**Re: SPLP Response to Comments  
Hydrogeological Reevaluation Report  
Valley Road Crossing HDD (S3-0591)  
DEP Permit Nos. E23-524  
Middletown Township, Delaware County, Pennsylvania**

**ATTACHMENT 1**  
**WATER SUPPLY ILLUSTRATION**

**HDD PROFILES WITH WELL LOCATIONS, WATER LEVELS, AND FRACTURE TRACE LINES**

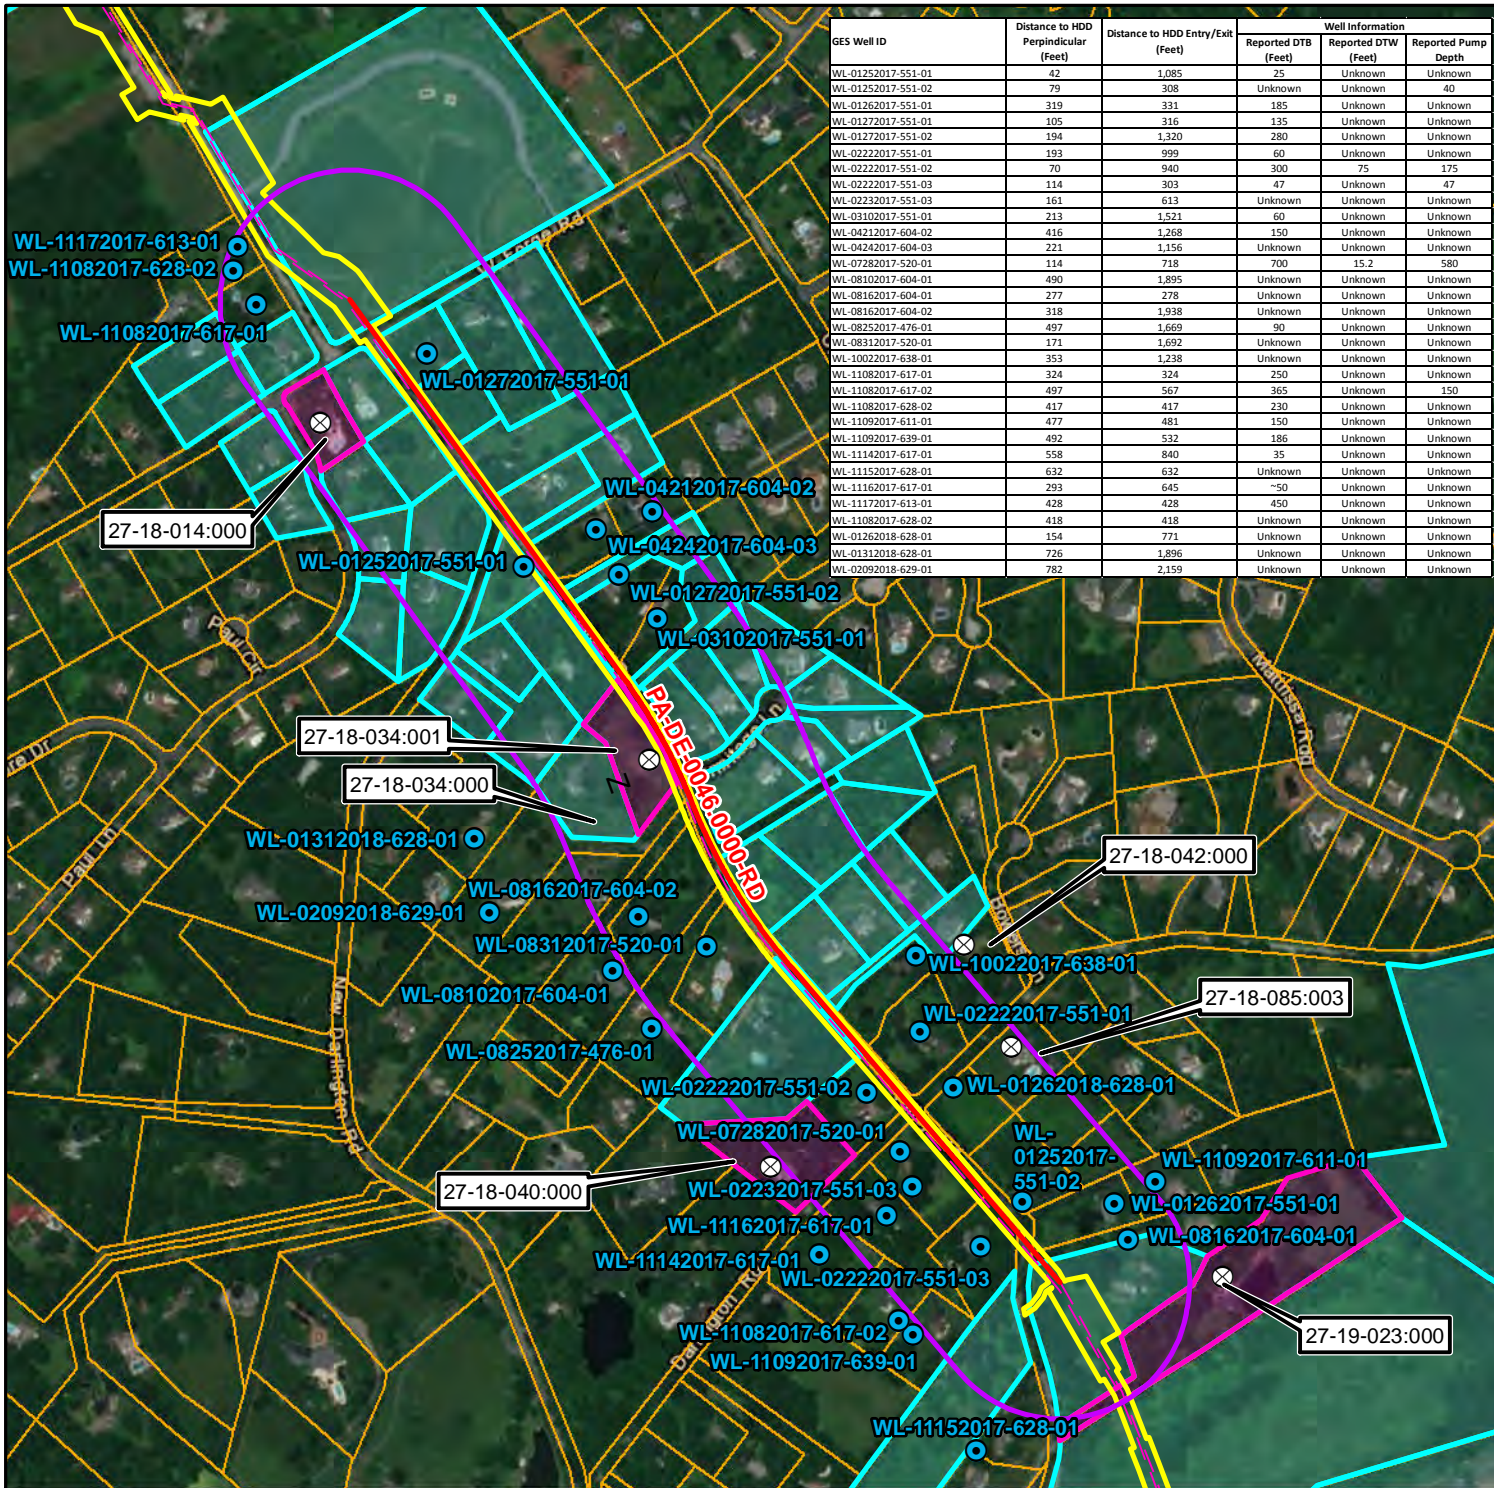
**c. The implementation of the early detection groundwater monitoring program using domestic wells described in the GES Report was not incorporated into the First Report. For additional clarification, please provide a map of the domestic wells, along with a time frame of drilling activities, within the monitoring plan.**

- 19. Figure 4 of the GES Report appears to be an earlier version and conflicts with what appears to be a later version of the same figure located in Attachment 2 of the GES Report. Figure 4 includes a table listing 20 wells, while the later version in Attachment 2 lists 28 wells. In addition, the text of the GES Report (Section 2.3.4) includes reference to 18 homes identified by the PAGWIS search, and then describes 28 properties & 20 domestic wells within the 450-ft search area. Based on the figure in Attachment 2 of the GES Report, DEP believes 83 properties are located within 450 feet of the proposed HDD, 28 of which have private water supply wells. These discrepancies should be clarified and SPLP should confirm that all private water supply owners have been contacted.**

- 27. There was a public comment received regarding the location of a private well at 226 Valley Road, in Media PA. The Well Location Map incorrectly locates GES Well ID WL-08102017-604-01 at an offset of 490 feet. The correct offset is 150 feet. Please revise the location and all appropriate action for this well to reflect this revised offset.**

A new Water Supply Illustration is provided with this response as Attachment 1. As shown on this illustration there are twenty-six (26) landowner identified private water wells within 450 ft of the HDD profile. Of these, two (2) have public water as a primary water source, and

As referenced in Item 4 of this response, an updated Water Supply Illustration is provided as Attachment 1. As shown on this illustration there are 24 tracts with private water wells, of which 2 have public water as a primary source, and 2 additional tracts potentially have public water as a primary source.

The updated Water Supply Illustration in Attachment 1 has been corrected.

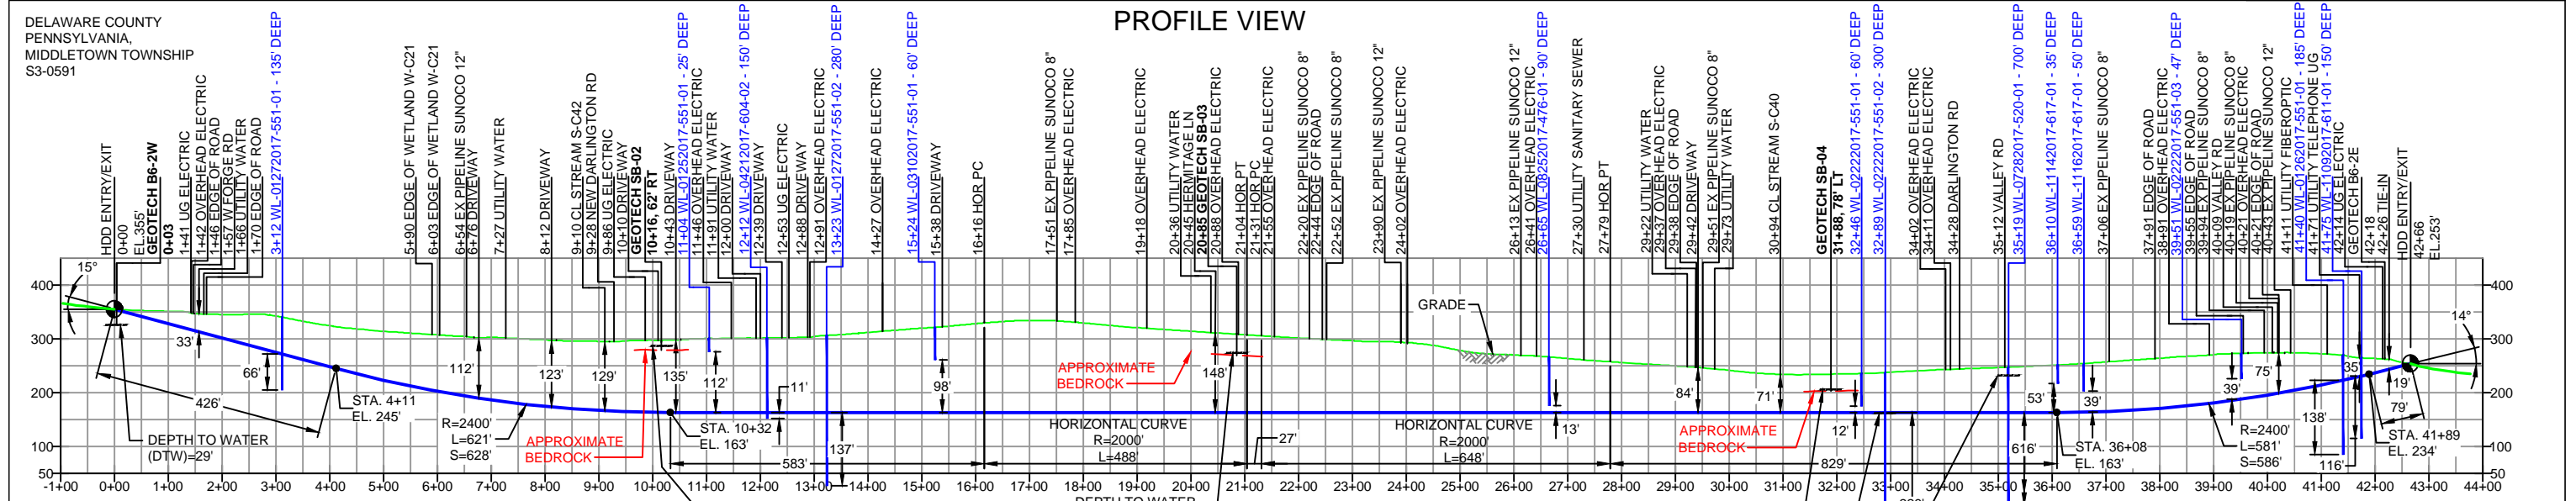
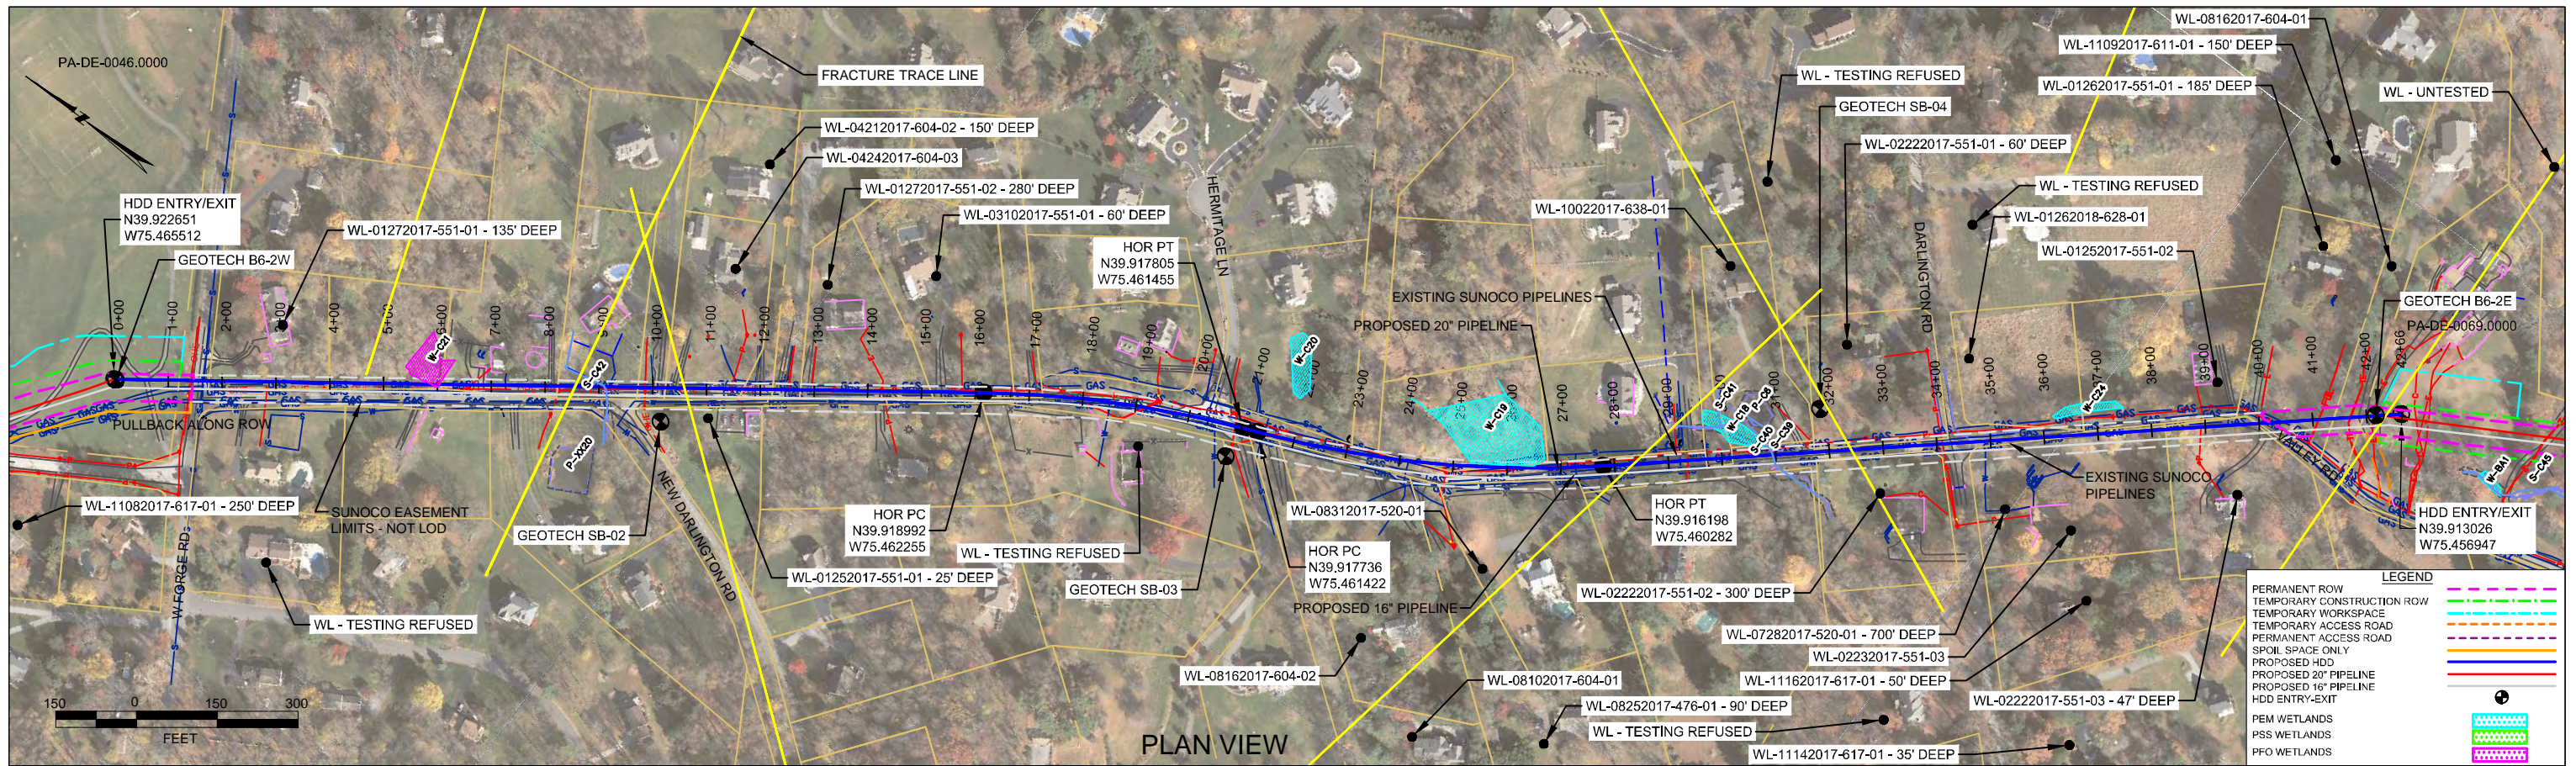
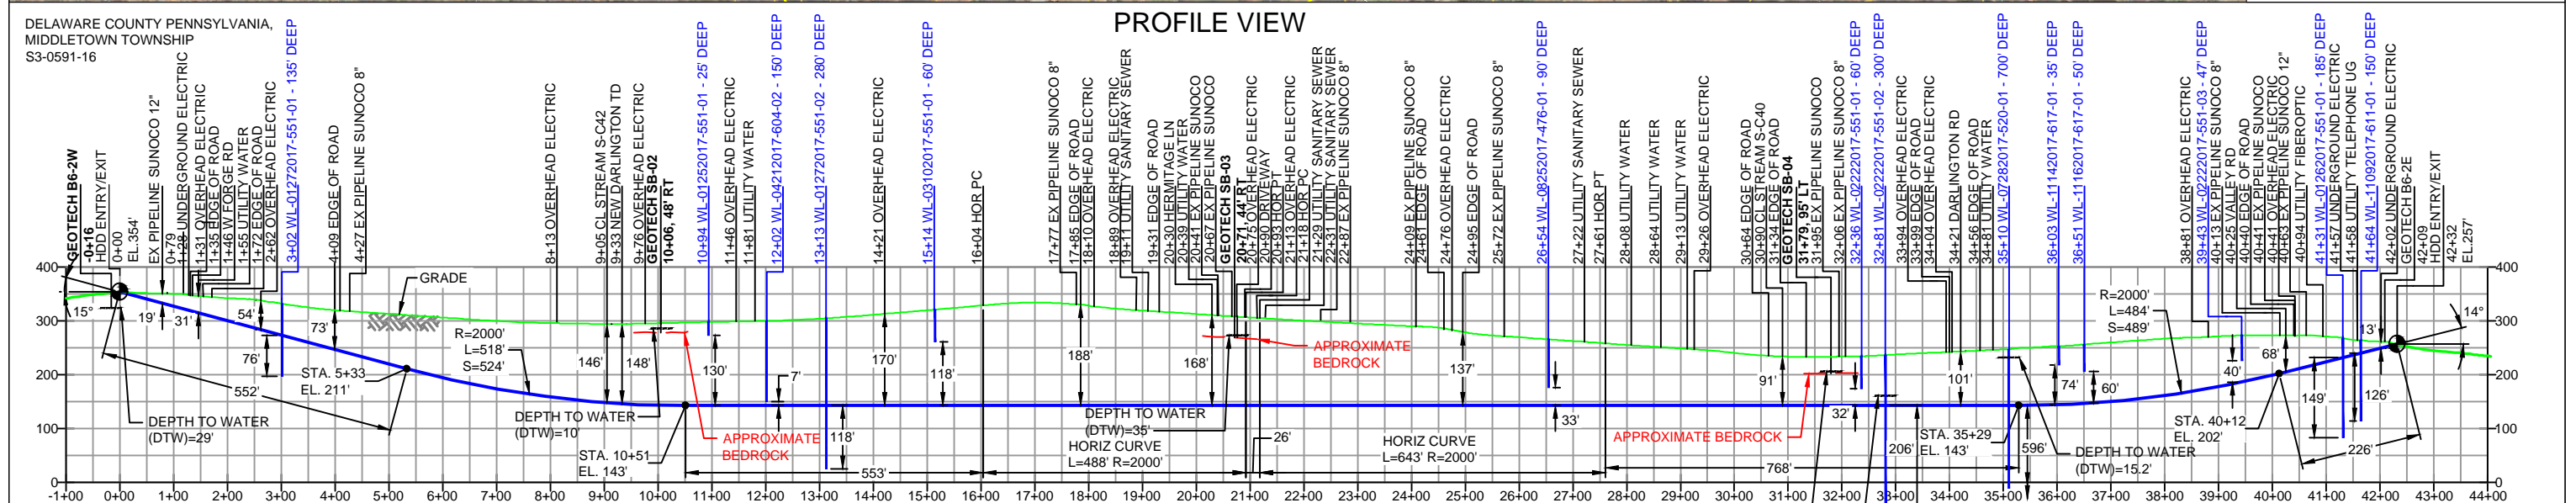
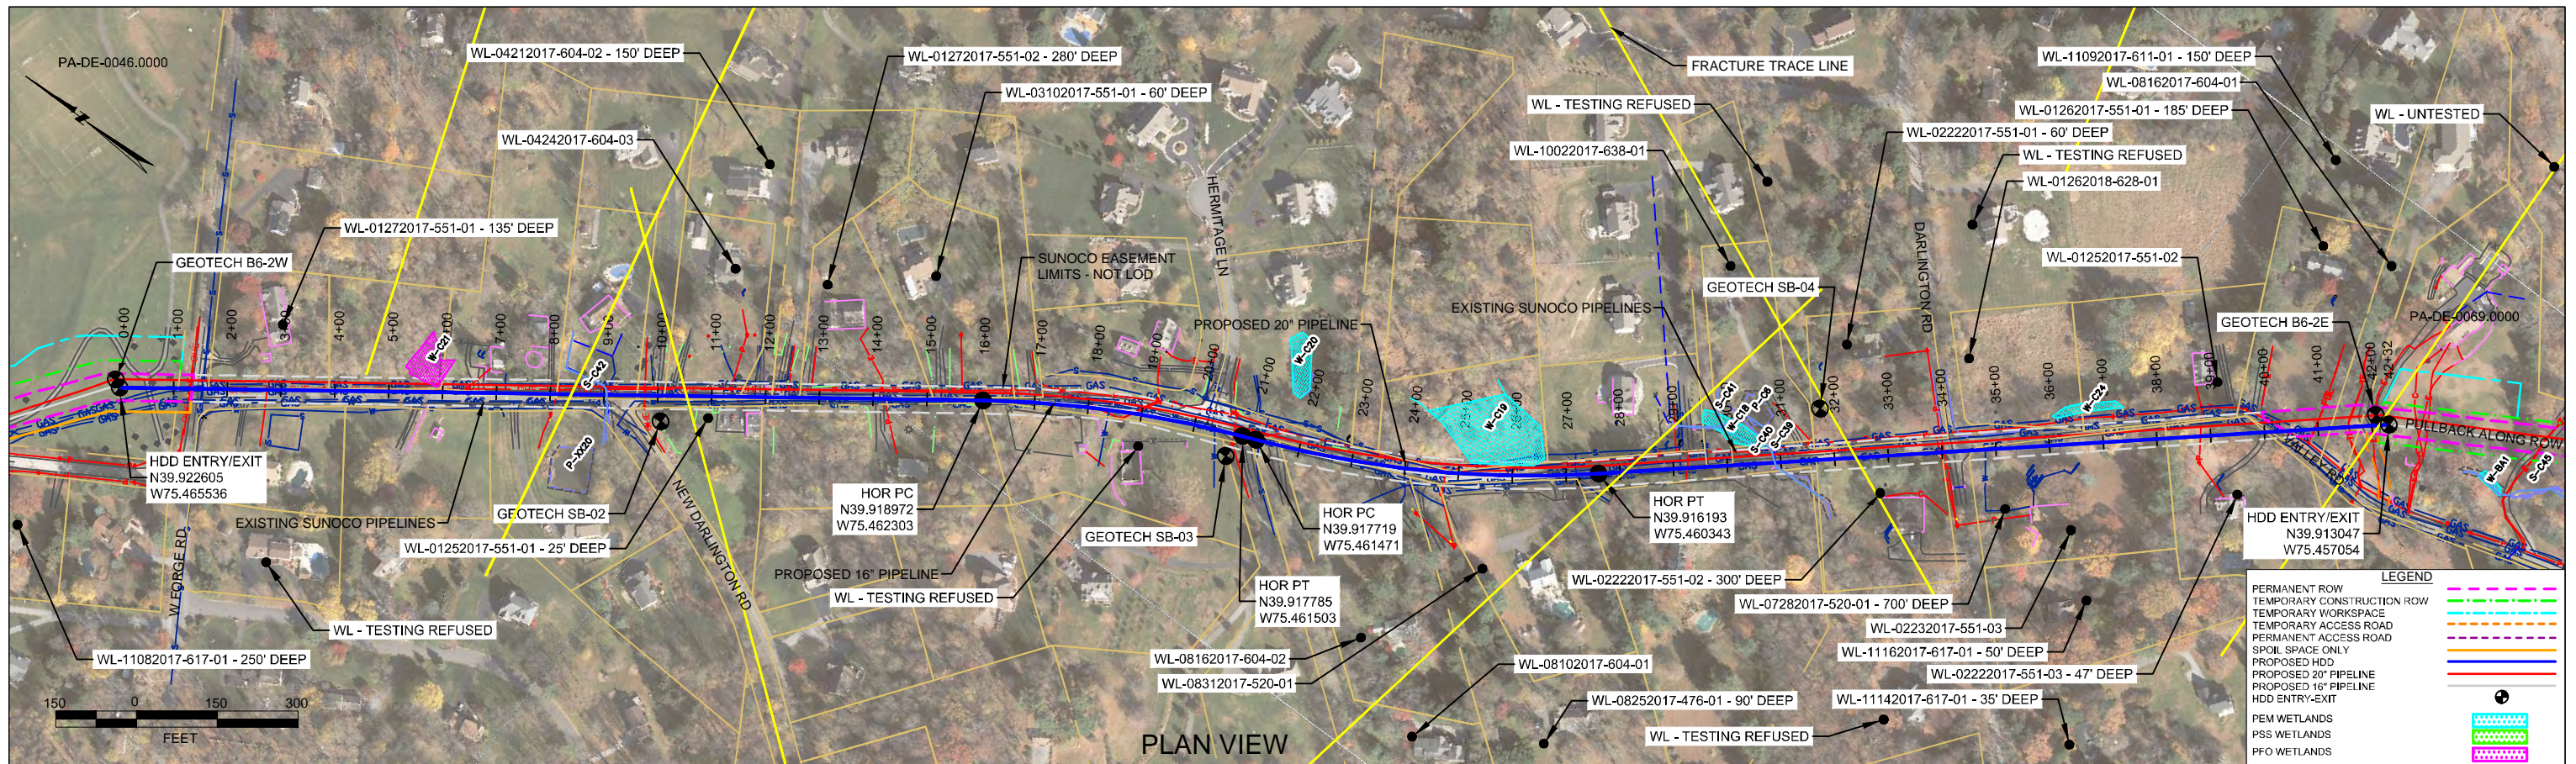
**a. Project water well depths, casing depths and water-level depths (based on a water-level survey) on cross sections/profile views.**

- b. The GES Report identifies fracture traces on a plan view. The Re-Analysis Report should also identify potential zones of fractures or fracture trace intercepts, and the residential water supply wells on the plan view and profile view figures.**

A set of HDD Plan and Profiles with water well locations, well depths, and water levels transposed onto the profiles is provided in Attachment 3.

A set of HDD Plan and Profiles with the fracture trace lines and water well locations transposed onto the profiles is provided in Attachment 3.
